June 16, 2009

RE: Request for Additional Information – Amendments to License Condition 74, Materials License SUA-56, Western Nuclear, Inc., Split Rock Site, Jeffrey City, Wyoming (TAC J00577)

Figure 1
Selenium Concentrations
Wells Up-Gradient of POC Wells

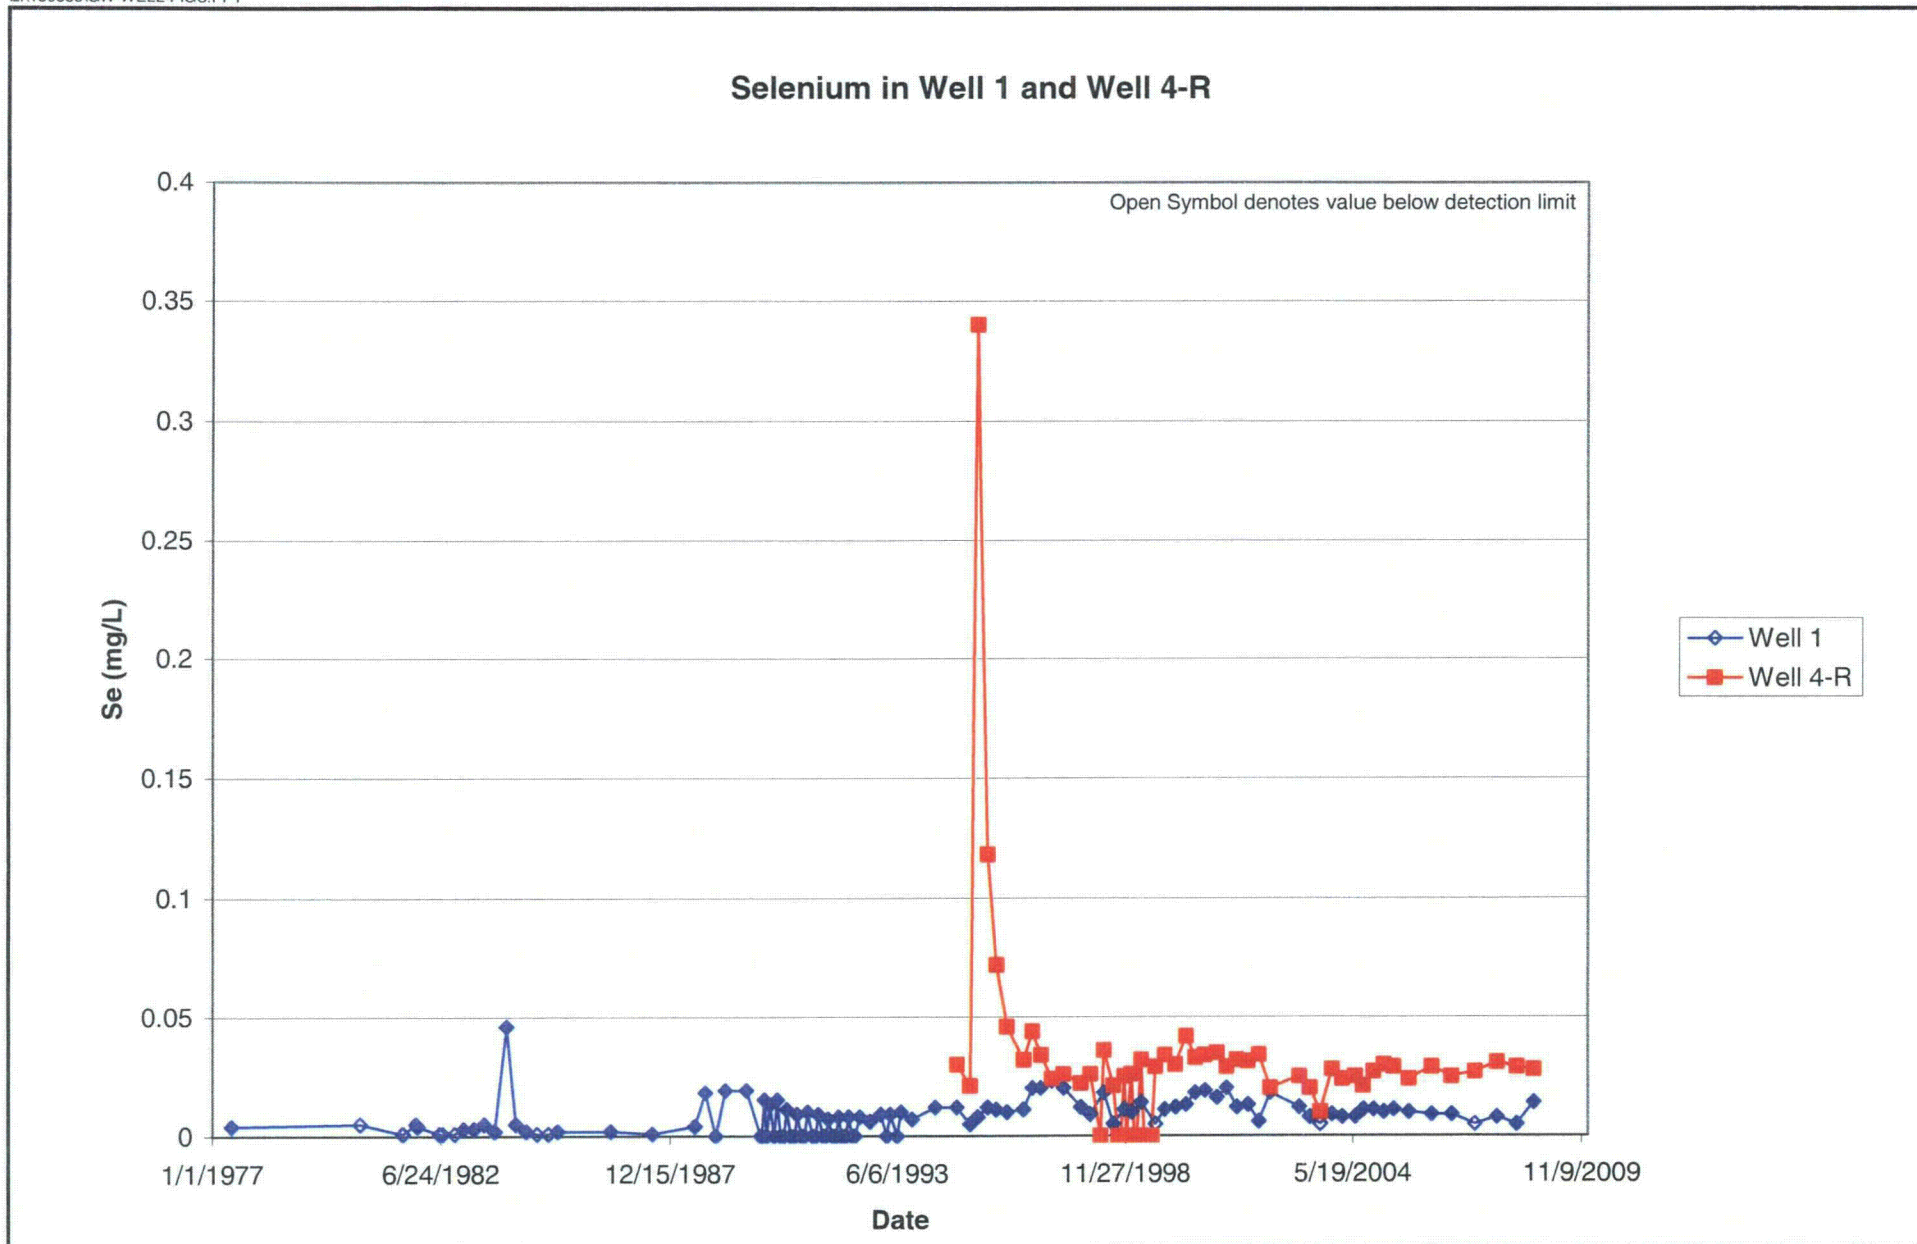
3. Confirm that selenium is not expected to travel outside of the impoundment above the requested value (0.05 mg/L) given that values at well WN-42A have, in the recent past, approached this value.

Selenium concentrations in groundwater have been measured for many years. The data indicate a slow decline in concentrations in the wells within and close to the reclaimed tailings and mill area. Specifically, wells 1 and 4R which are up-gradient of the point of compliance wells have values since 1996 which remain less than the proposed standard of 0.05 mg/l. The POC wells, 5 and 21, indicate that the selenium values

have remained less than the proposed standard for approximately 30 years. Well 21 has always had selenium values that are very low and for the most part less than the detection limit. The selenium values for well 5 have been as high as approximately 0.03 mg/l in the past with the recent values decreasing to approximately 0.02 mg/l. All the selenium values for the POC wells, going back 30 years, are less than the proposed standard for selenium.

The other monitoring wells, with the exception of well 42A have selenium values that are constant and general at or less than 0.01 mg/l. The selenium values in well 42A have been as high as 0.042 mg/l in 2007 with the 2008 data averaging approximately 0.03 mg/l. The selenium concentrations for all the wells are shown on Figures 1-3 and the location of the wells is shown on Figure 4.

The data clearly show that the POC wells, and the wells that are up-gradient of the POC wells have selenium concentrations that are less than the proposed standards and are either constant or have decreasing concentrations. The wells downgradient from the POC wells all have much lower selenium concentrations than the POC wells with the exception of well 42 A. This well has concentrations that are less than the standard and appear to be stable or declining. The higher selenium concentrations in well 42 A are likely the result of a pulse of water with slightly elevated selenium values that continues to move from the tailings area and the constituents continue to disperse, attenuate and be diluted. Since the concentrations at the source (i.e. wells 4R and 5) and the POC wells are less than the standard, the selenium concentrations in well 42A will slowly reduce as concentrations continue to decline and attenuation and dilution continue to reduce the concentrations as groundwater flows away from the tailings impoundment.

Figure 1
SWAB-1 and SWAB-1R Well Completion Diagram

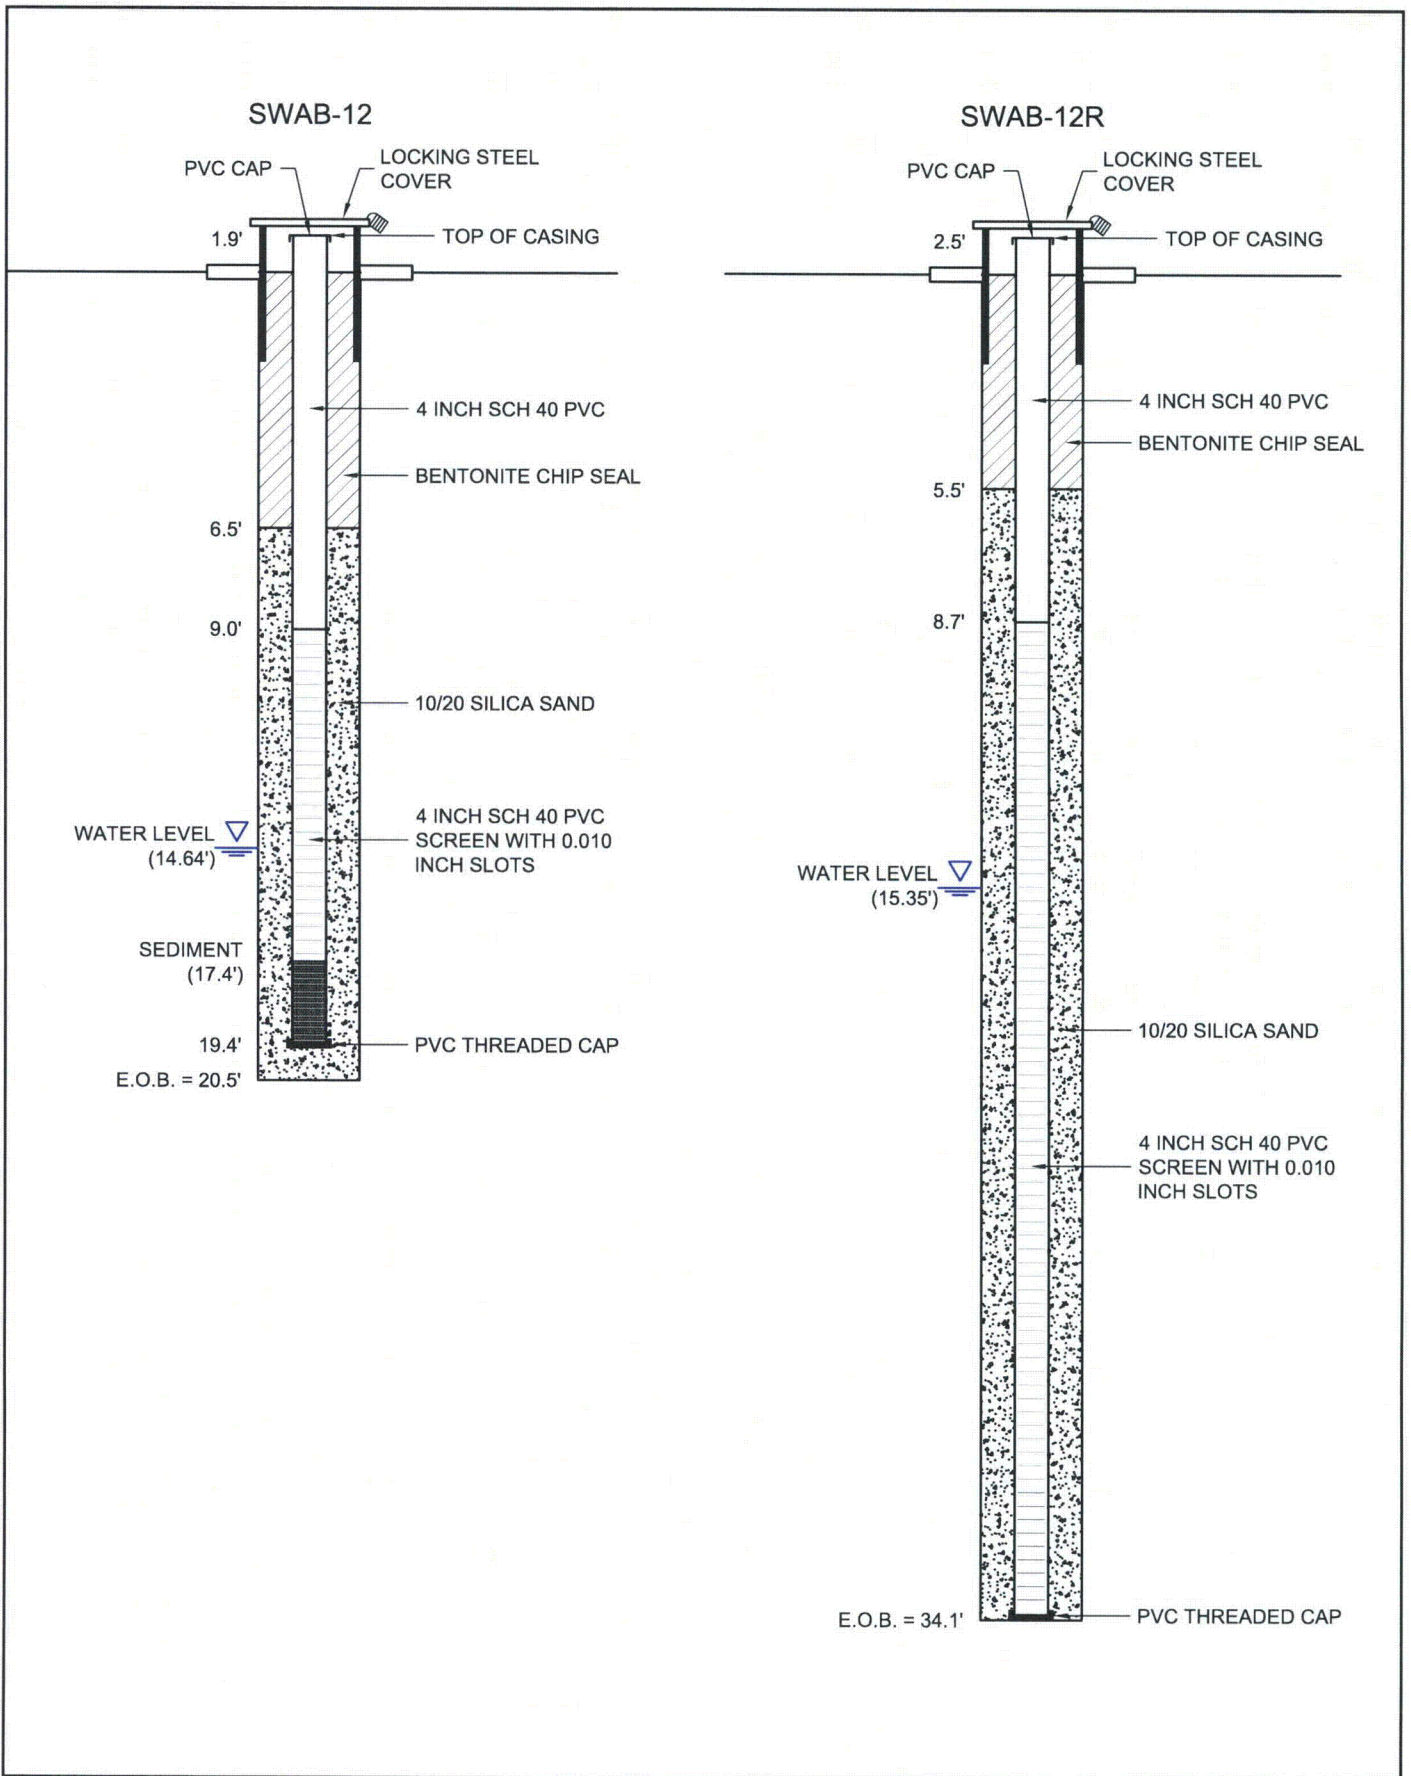
4. Is the fact that wells SWAB-1 and SWAB-12 contain insufficient water to provide a valid sample, as stated in your February 26, 2009, Surface Water and Groundwater Monitoring Report, change WNI's conclusions on aquifer flow and transport?

SWAB-1 and SWAB-12 were replaced by drilling deeper wells adjacent to the existing wells. These wells are viewed as replacement wells by the Wyoming State Engineer's office and have the same identification number as the previous wells. The completion details for the replacement wells are shown in the attached memorandum.

Water level in the replacement wells (SWAB -1 R and SWAB-12R) were measured and water quality samples were taken from the wells during the May 2009 sampling episode. Water levels in wells SAB-1 and SWAB-12 have declined approximately 3 feet since the wells were installed in 1996. Similarly, water levels in the other wells to the south of the site have also declined. Figure 5 shows the approximate water levels in the wells to the south of the site in 1996 and 2008. As can be seen, while the water levels have declined, the general groundwater flow directions have remained the same.
